**Addendum #2**

PROJECT #: NT-0050-B01
New Leonard Place Elementary School
Passaic Public Schools

DESCRIPTION: Addendum #2

AI-103

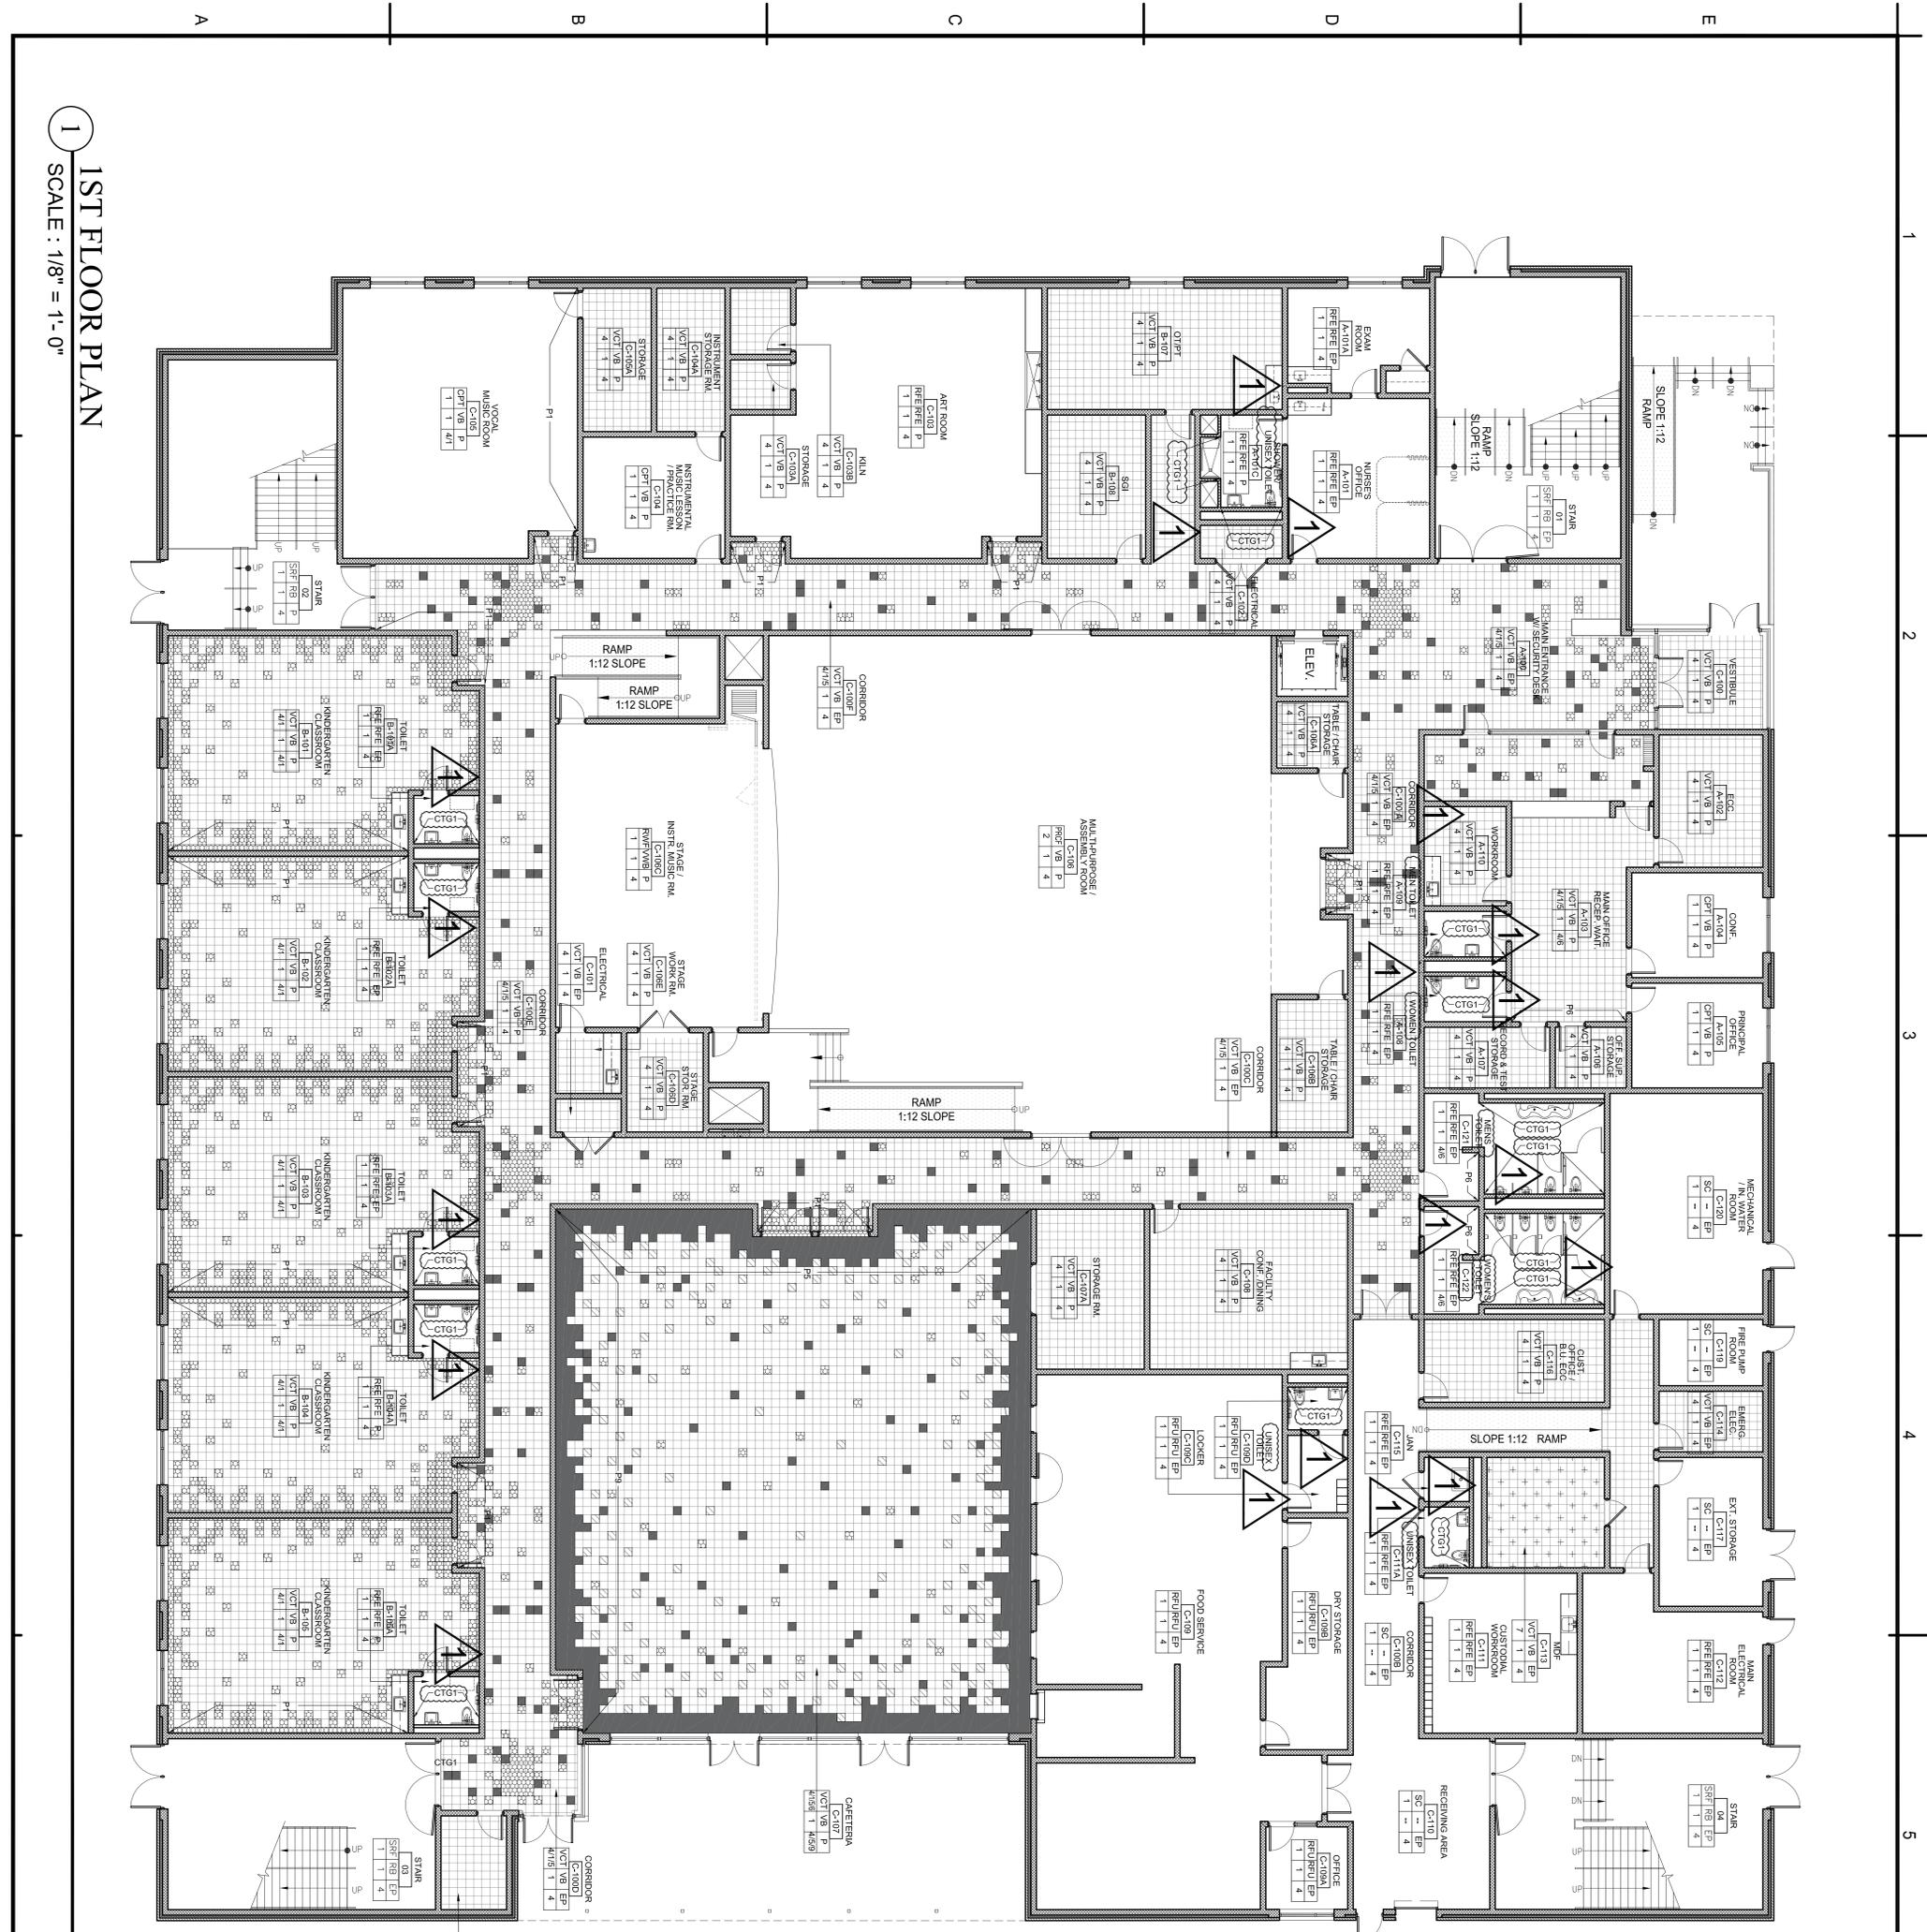
- Answer: Ceramic tile is required. See Sheet AI-101, AI-102 and AI-103; dated August 7, 2015; Revised Addendum #1, dated September 28, 2015.
11. Question: If required, what is the height of ceramic tile at toilet room wet walls?

- Answer: The height of the ceramic tile at the Toilet Room wet walls will extend from the top of the integral epoxy floor base to the ceiling.
12. Question: What is the finish transition detail between the Integral epoxy wall base and the ceramic wall tile at the wet walls?

- Answer: Extend the integral epoxy wall base 2" behind a bullnose tile, the edge of which aligns with the adjacent base.

Answer: Toilet rooms have been identified for both Student and Staff usage. See Sheet AI-101, AI-102 and AI-103; dated August 7, 2015; Revised Addendum #1, dated September 28, 2015.

AI-101

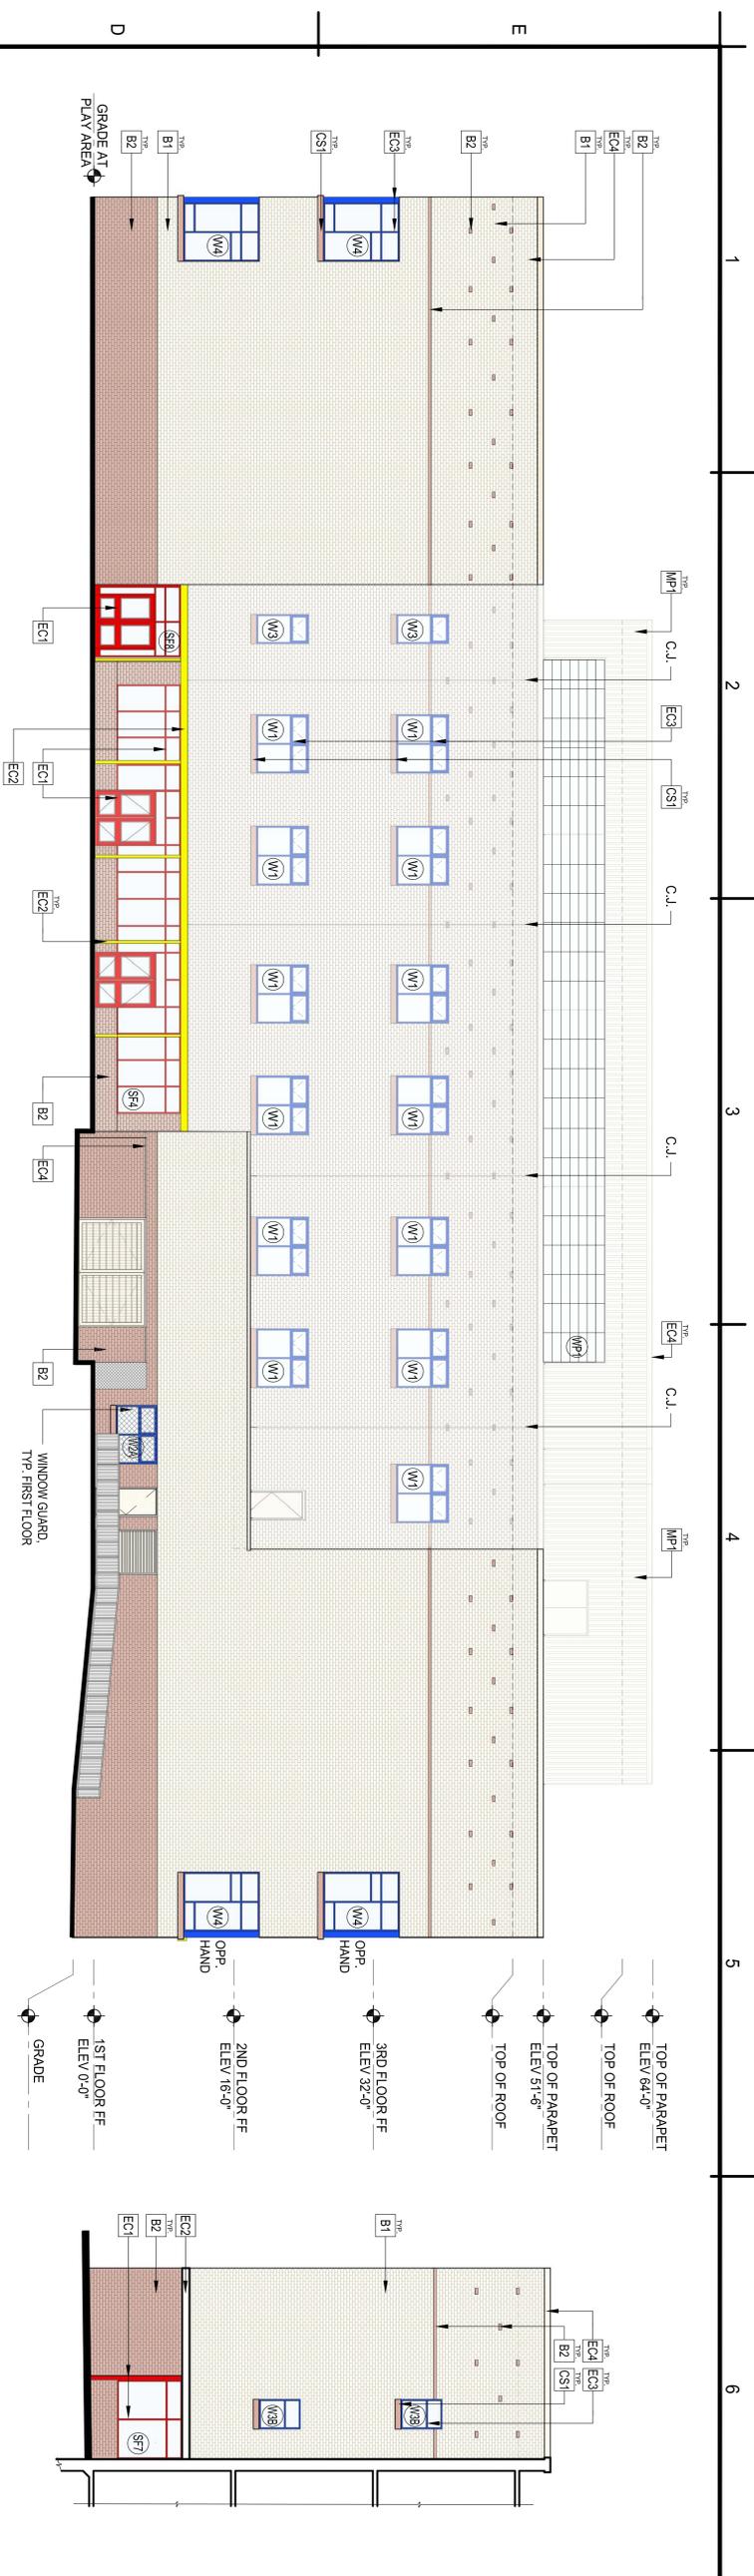
10. Question: Specifications indicate Staff, Student and Public Toilet to have Epoxy Painted walls with ceramic tile on only the wet walls. Interior Finish Drawings do not indicate ceramic tile on walls, only epoxy paint (EP). Please confirm if ceramic tile is required as indicated in the specifications.

14. Question: There are two rooms on drawing A-101 which have the same room #C-120, Mechanical/In Water Room and Girls Toilet. Please provide corrected Room Numbers.

Answer: The Room C-120 Mechanical/In Water Room is correct. The Girls Toilet Room has been renamed to Women's Toilet #C-122. See Sheet AI-101 and AI-102 dated August 7, 2015; Revised September 28, 2015.

PROJECT TITLE
S.O.A. PROJECT # 3970DNI11-07-00A-V
DRAWING #
A-102

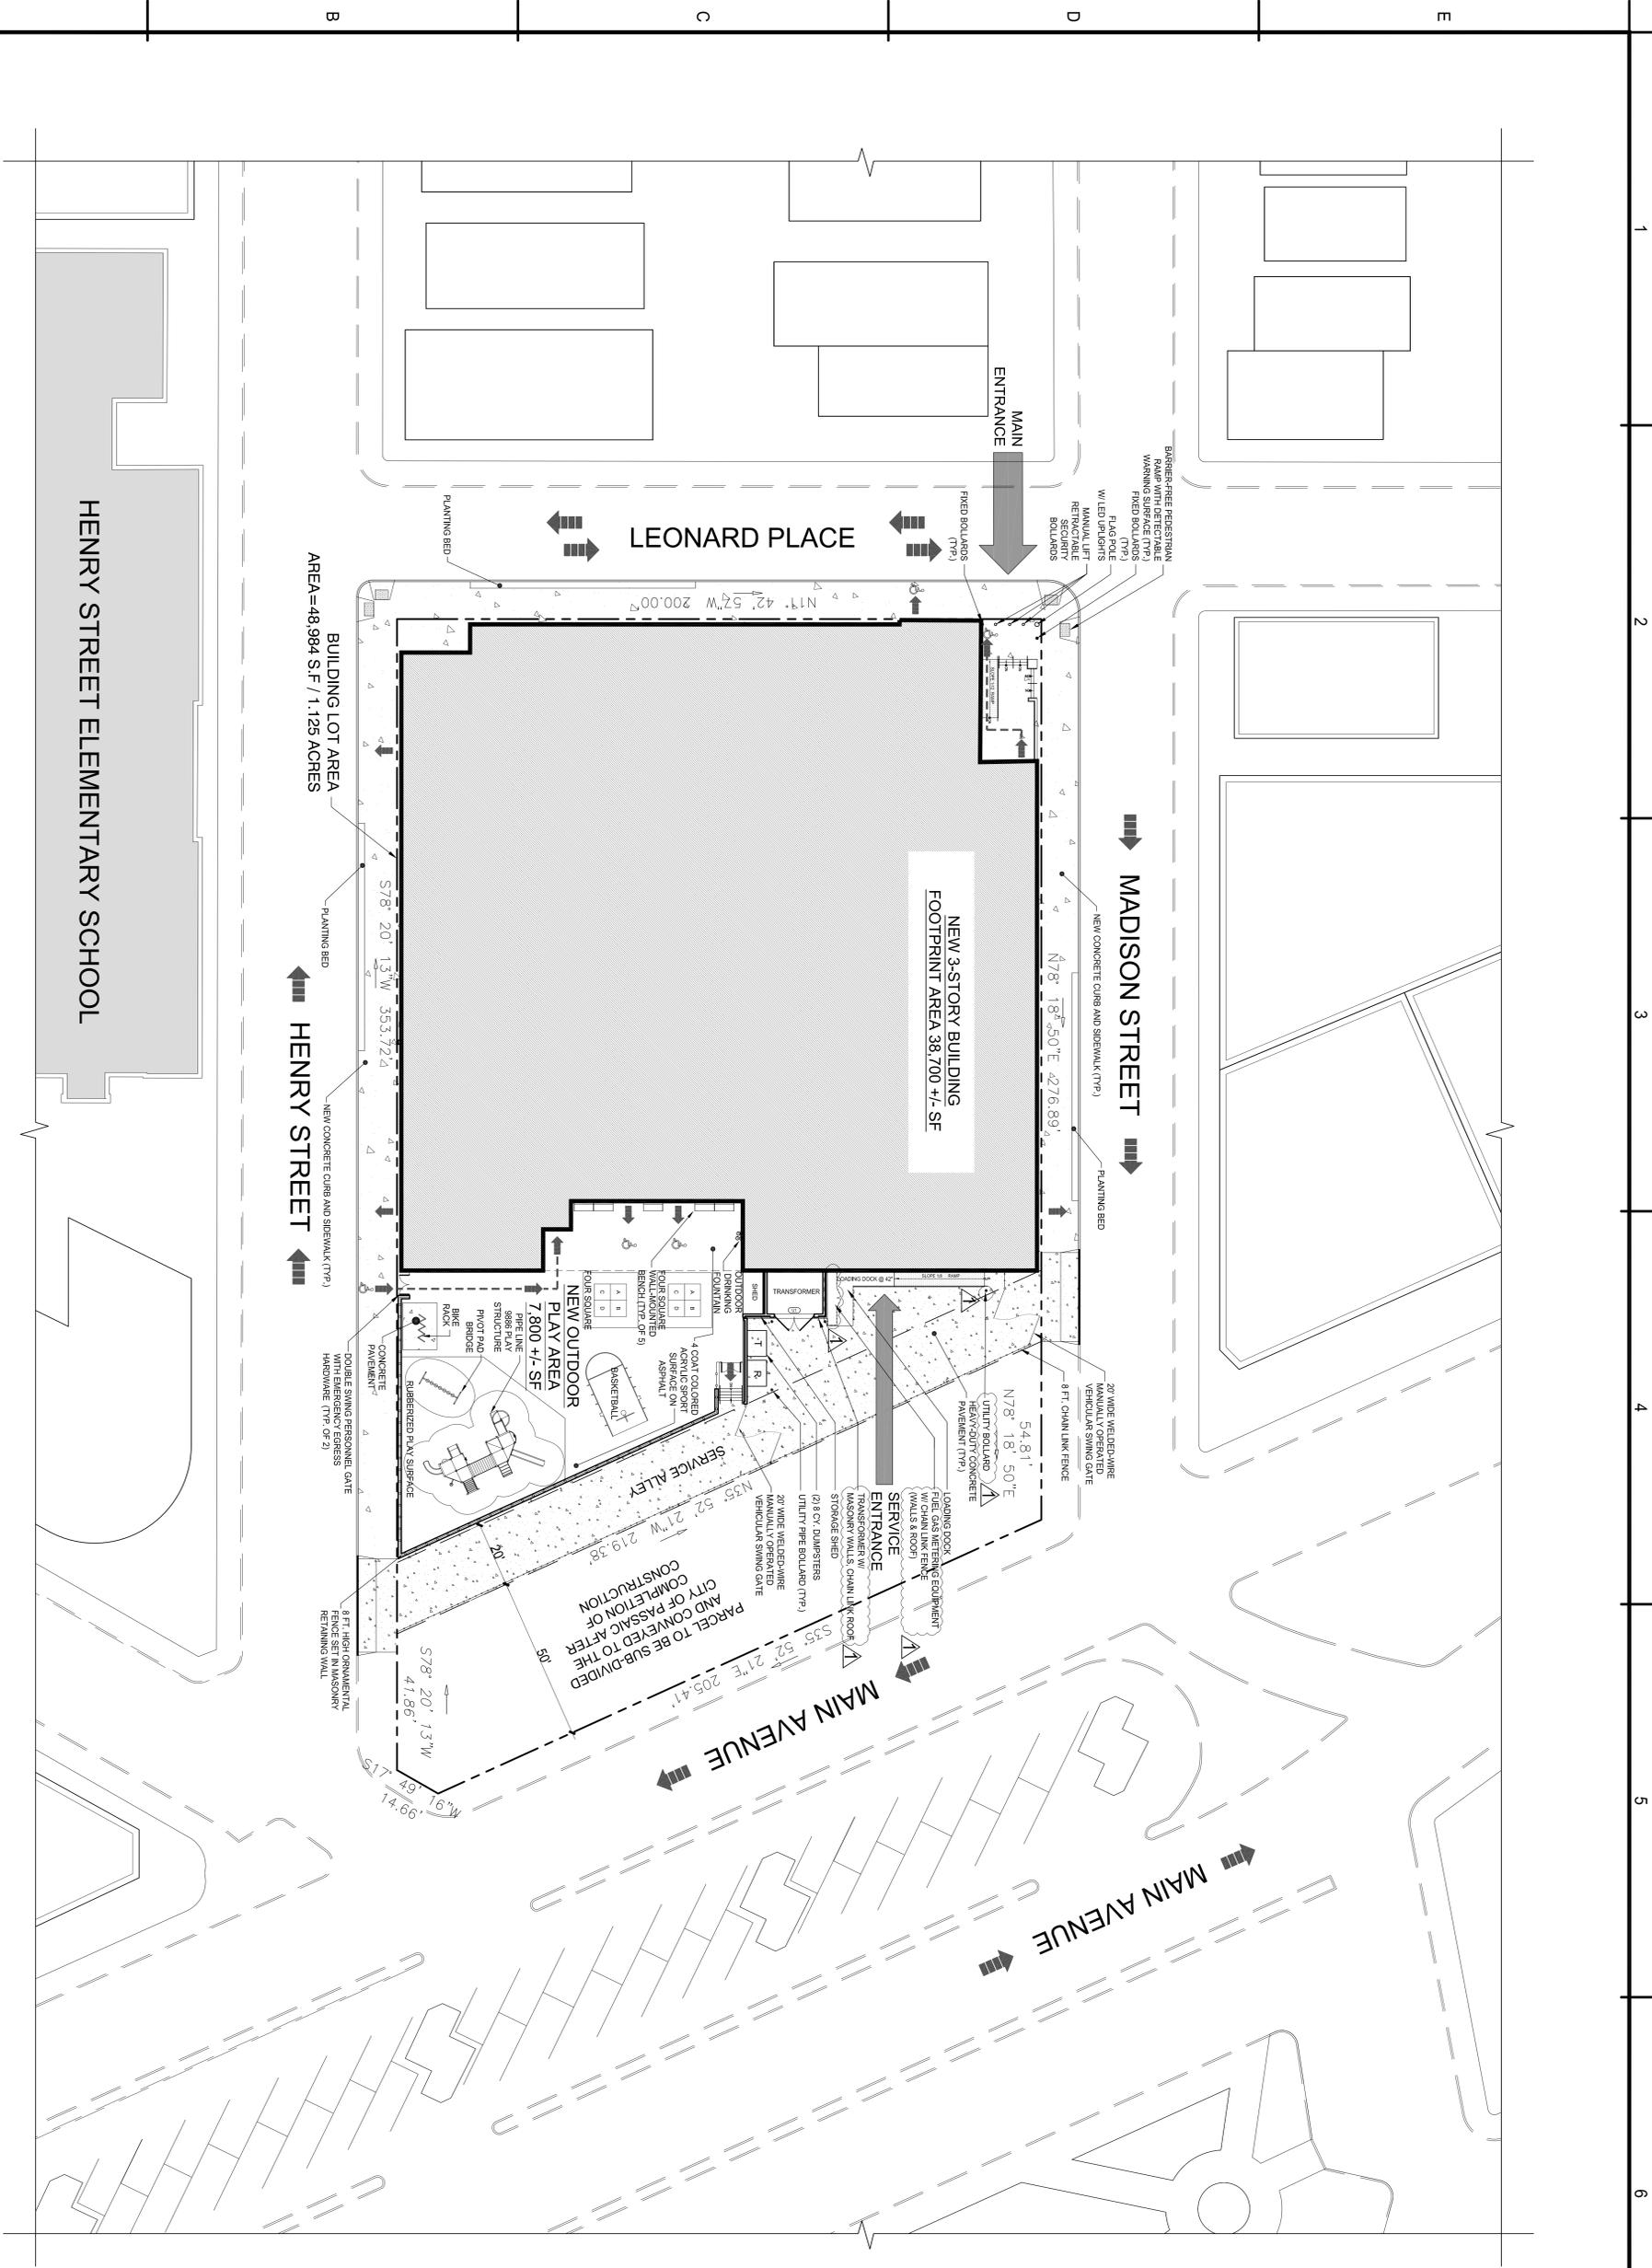
15. Question: There are corridors on the 2nd and 3rd floors which are both labeled C-300A. Please confirm that the 2nd floor corridor should be labeled C-200A.

Answer: The Second Floor Corridor name has been changed to C-200A. See Sheet A-102 and AI-102, dated August 7, 2015; Revised September 28, 2015.
